PLAN COMMISSION MEETING AGENDA

MONDAY, MARCH 25, 2024 AT 4:30 PM

TO: Plan Commission
DATE: March 25th, 2024
SUBJECT: 1207 Boomer Street, Conditional Use Permit - CUP

TO: Plan Commission
DATE: March 25th, 2024
SUBJECT: 672 Johnson Street, Conditional Use Permit - CUP

Sheet:
PROJECT LOCATION & GENERAL NOTES

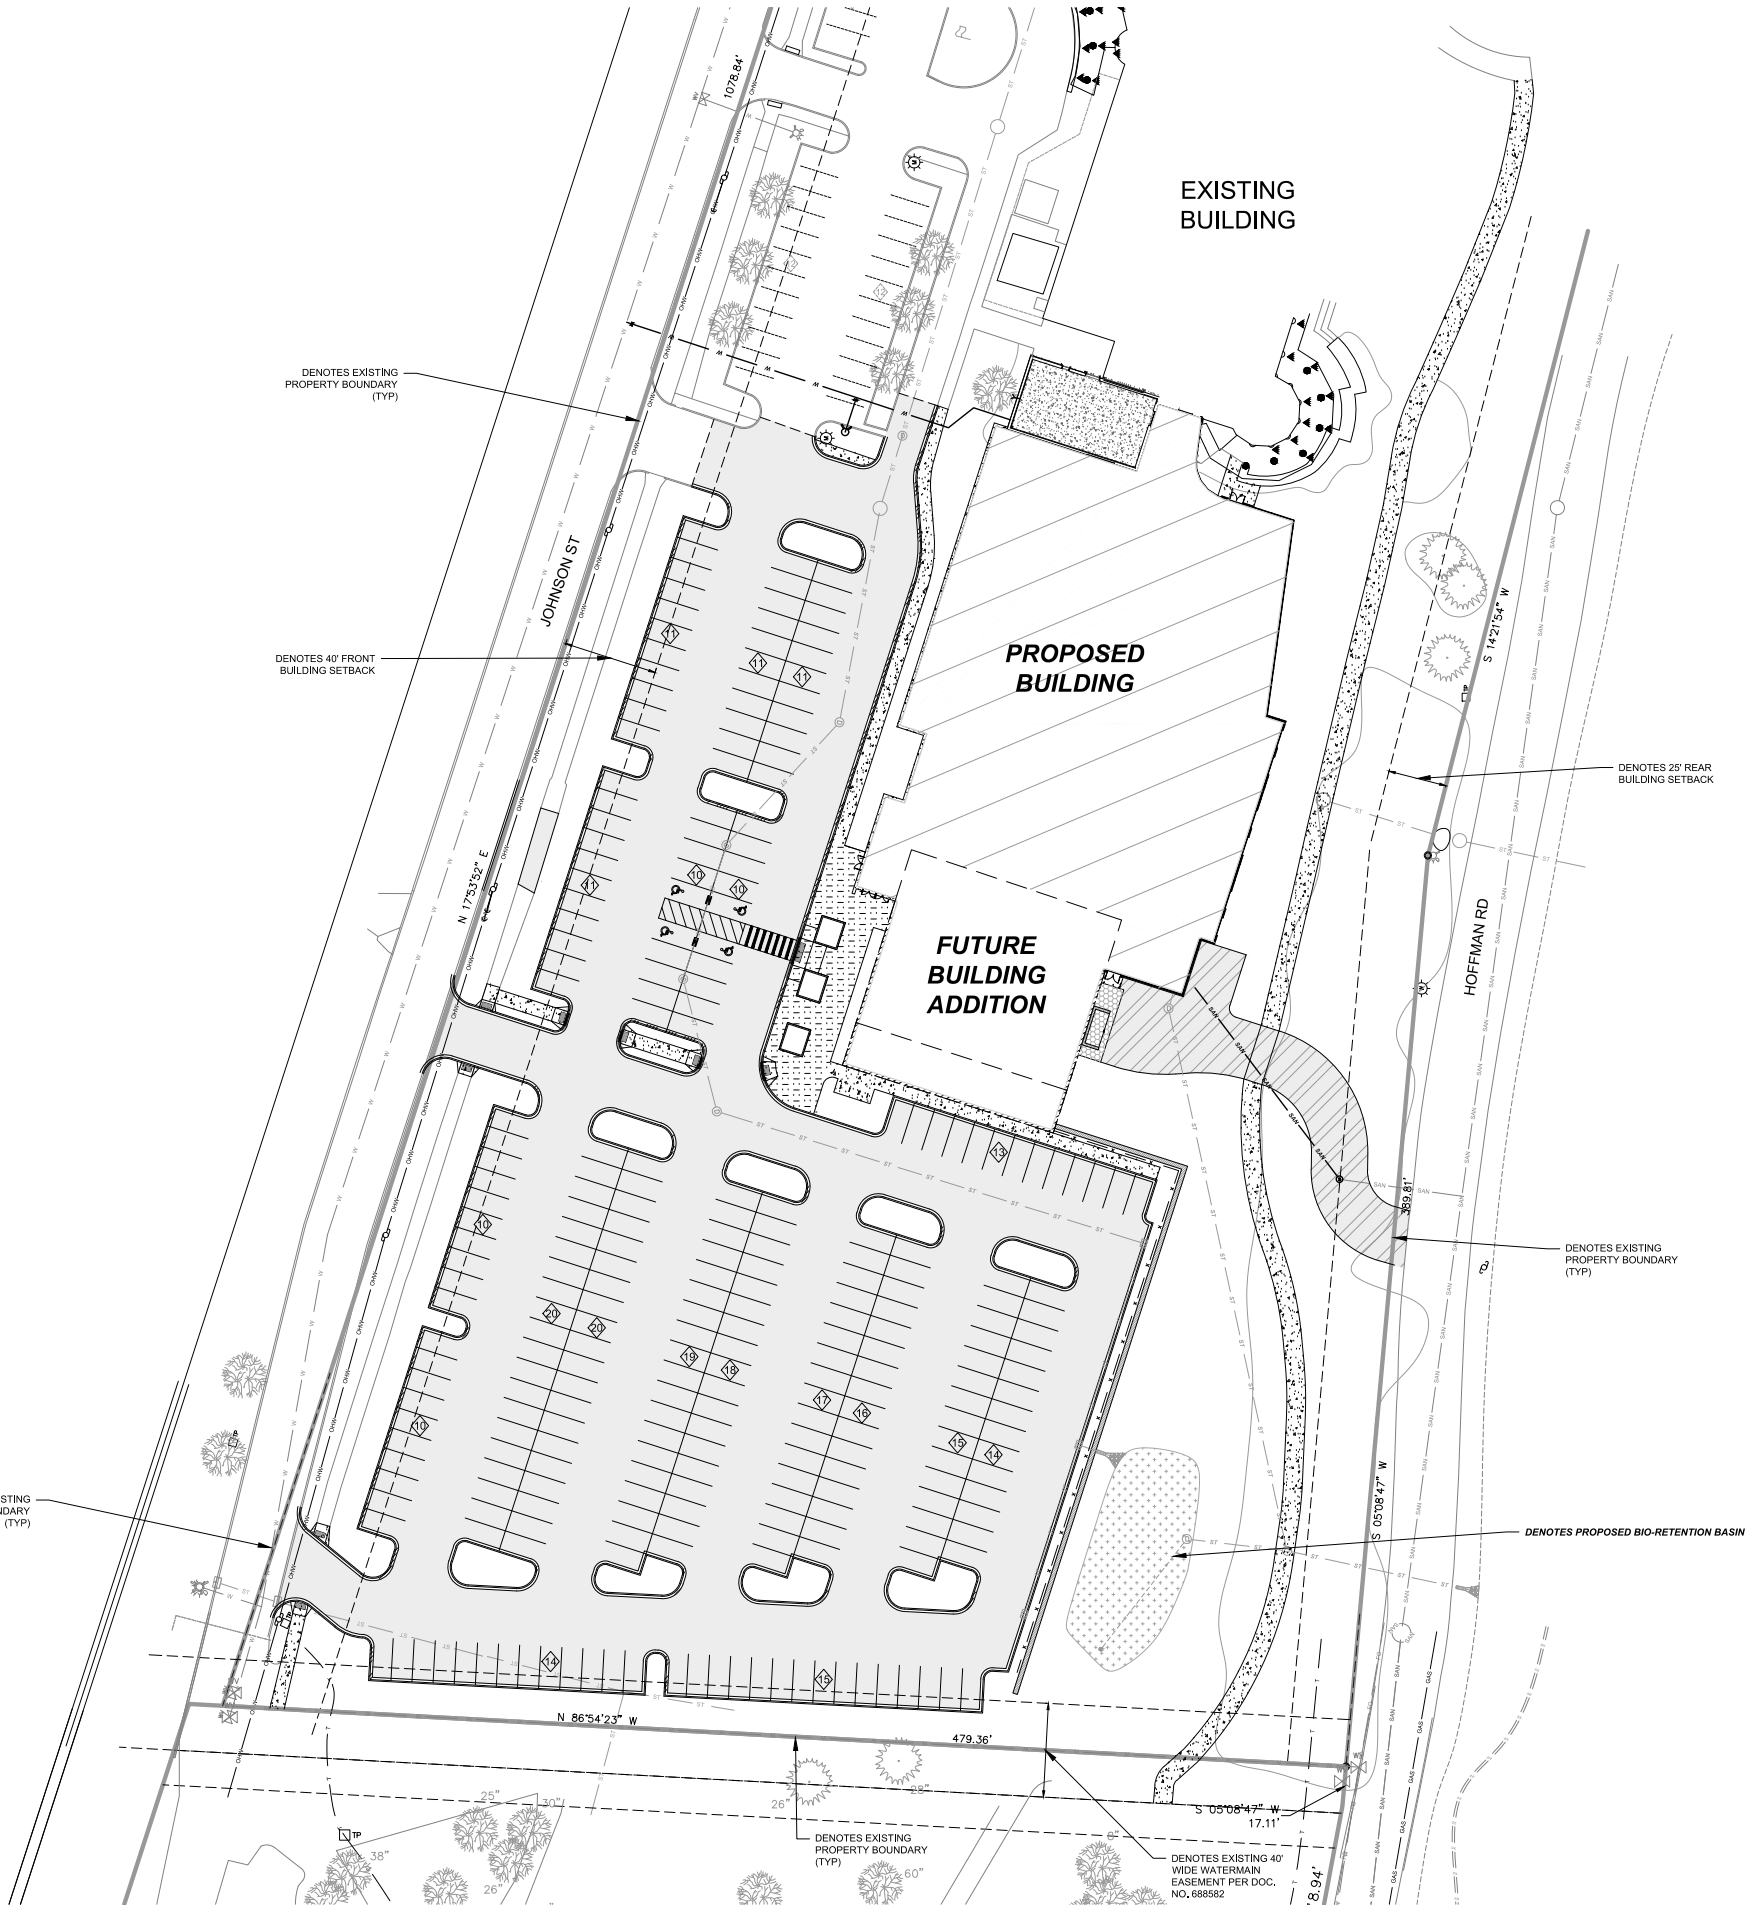
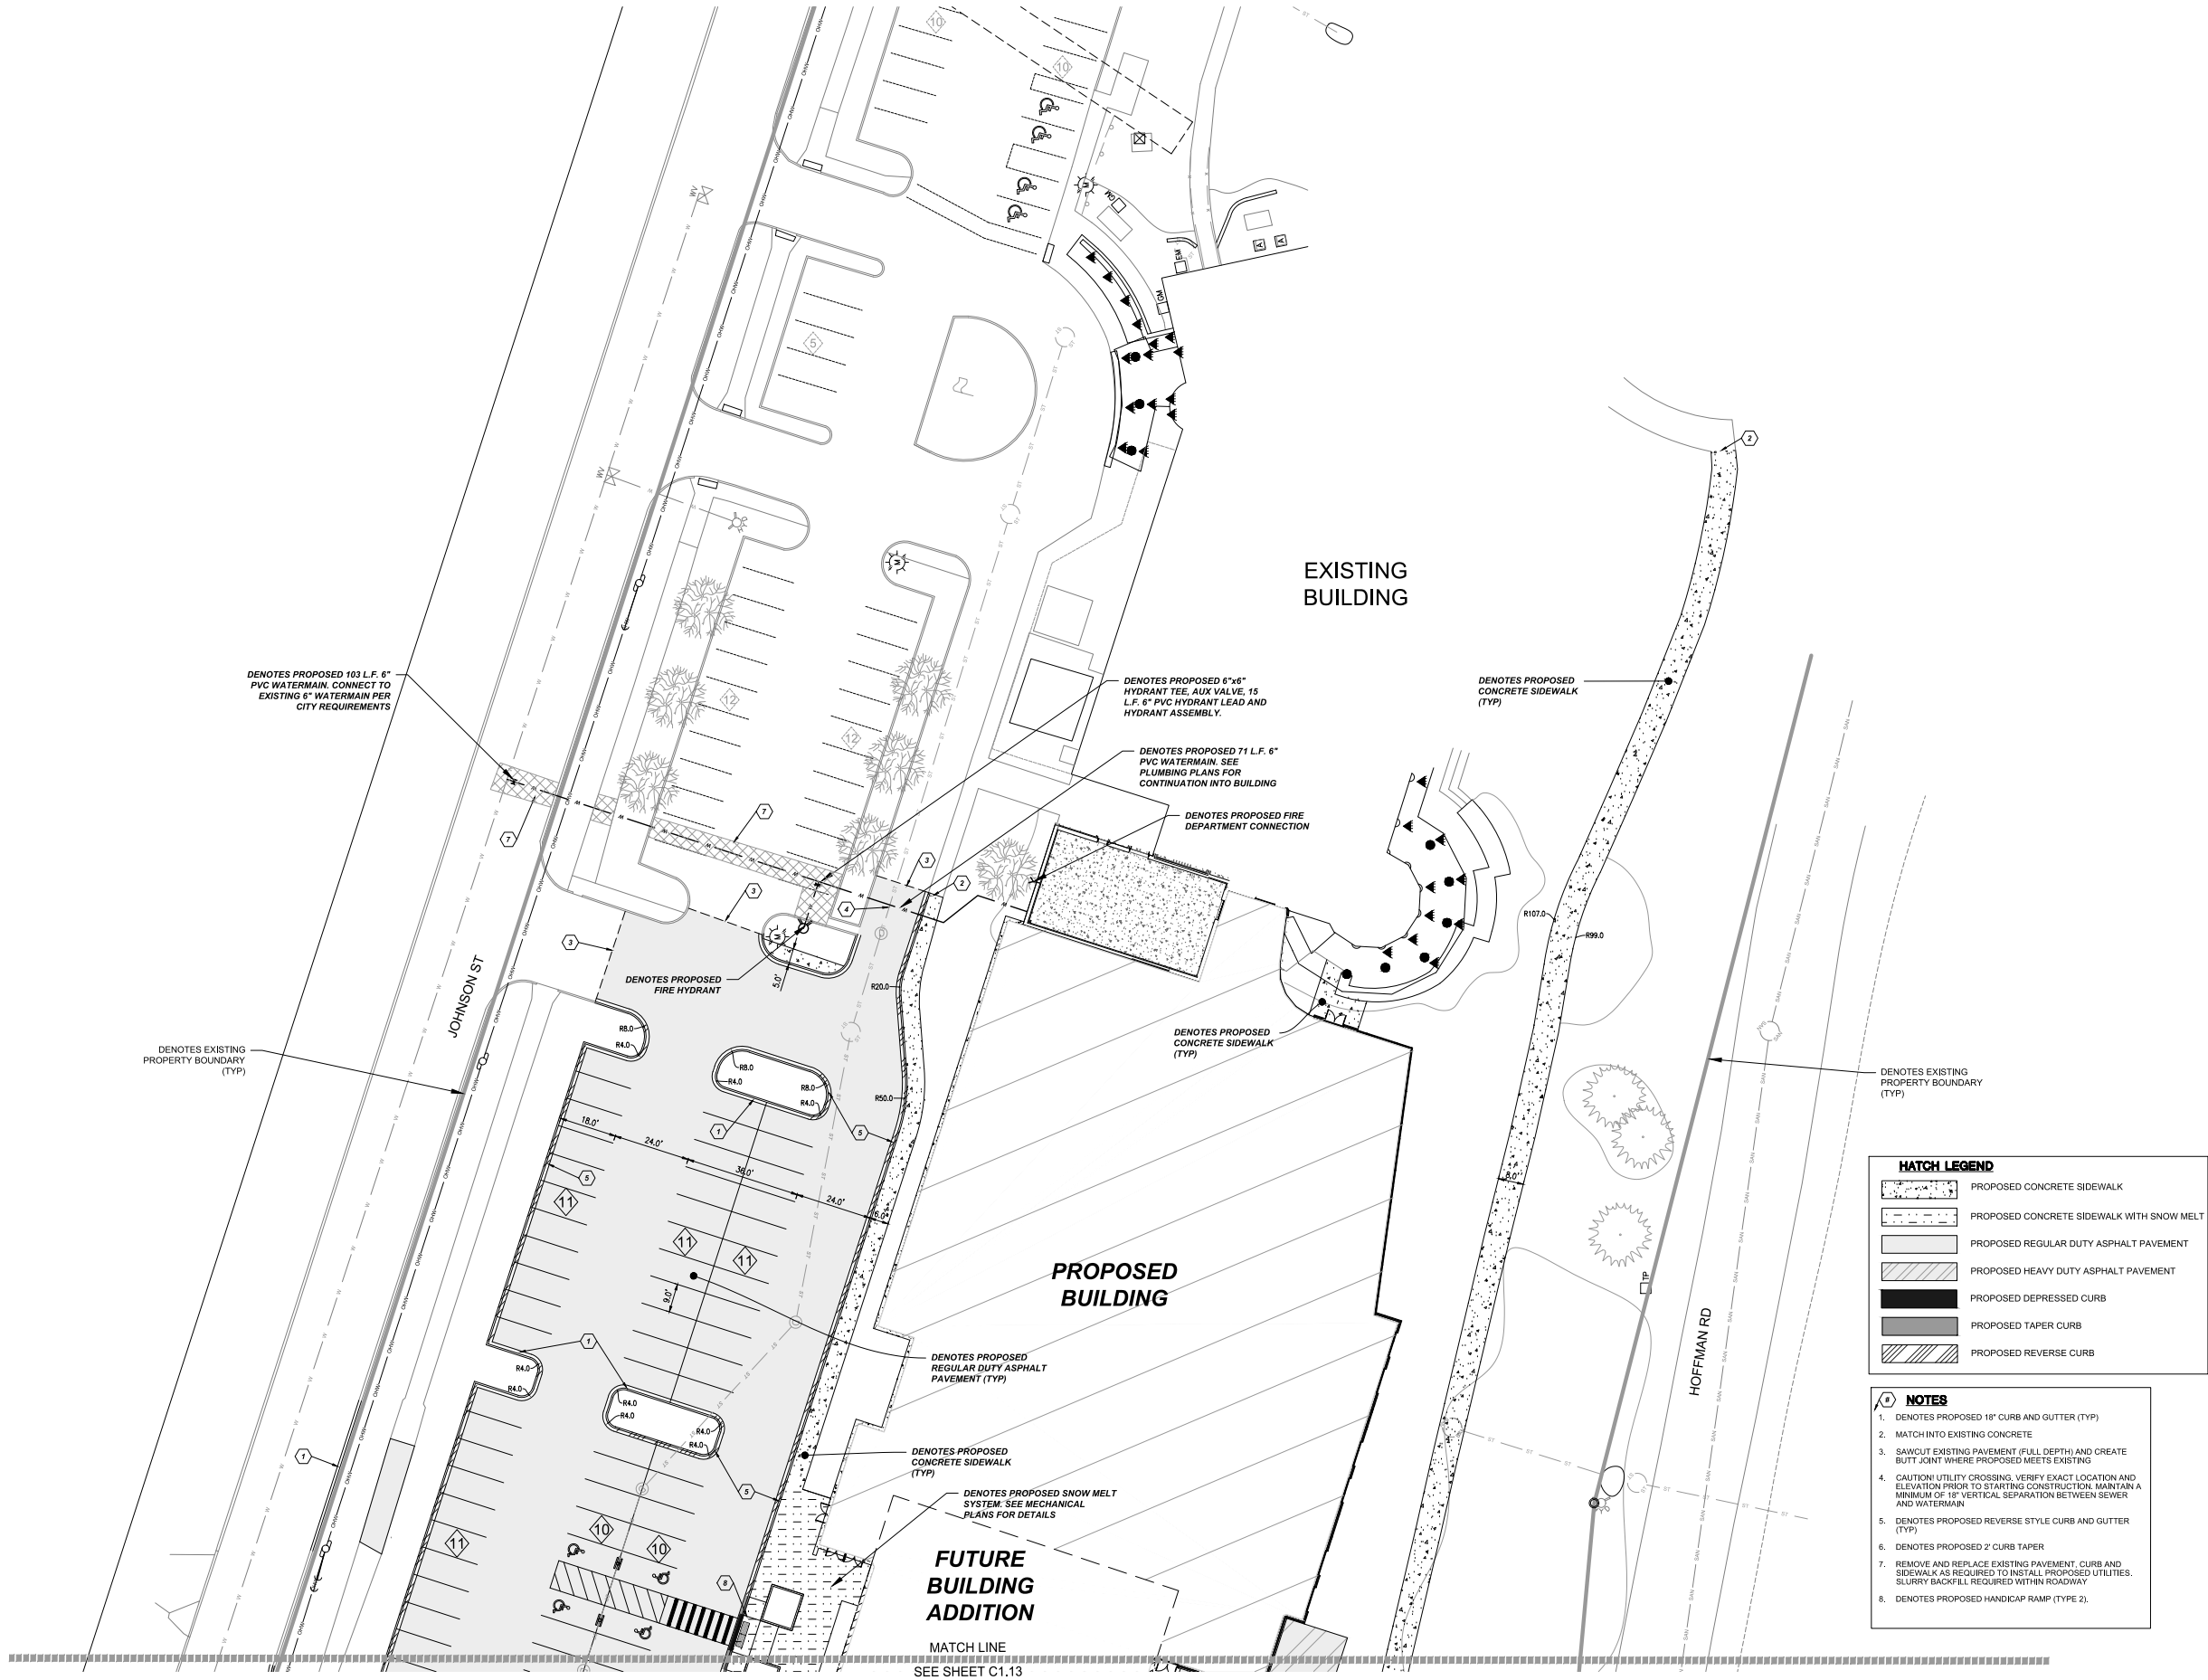
- (h) Parking lot design shall employ interior landscaped islands with a minimum of 400 square feet at all parking islands, and in addition shall provide a minimum of one landscaped island of a minimum of 400 square feet in each parking aisle for every 20 cars in that aisle. Aisle-end islands shall count toward meeting this requirement. Landscaped medians shall be used to break large parking areas into distinct pods, with a maximum of 100 spaces in any one pod. **Needs to be waived, requesting removal of the median island requirements in certain locations.**

- (n) Where such developments are proposed to provide a new location for a business already located within the community, a required condition of approval for the new development shall be a prohibition on conditions of sale, lease or use of the previously occupied building or site which provide limits beyond the range of applicable local, state or federal regulations. If such limits are required, the applicant may seek City approval to demolish the previously occupied structure and prepare the site for some future development. **Needs to be waived, the use of existing YMCA site to be determined at a later date.**

- (p) The Plan Commission may waive any of the above standards by a three-fourths' vote of members in attendance, but only if supplemental design elements or improvements are incorporated into the project that compensate for the waiver of the particular standard. **Three standards will need to be waived to approve this proposal.**

| Response | Requesting a waiver separating the 97 stalls from the 100 stalls on south end of the parking lot. Site is land locked and for program purposes to maximize parking, requesting to removed the requirement of the Median island only. |

| Response | Waiver, YMCA working with Board and community leaders to identify highest and best use of existing site |
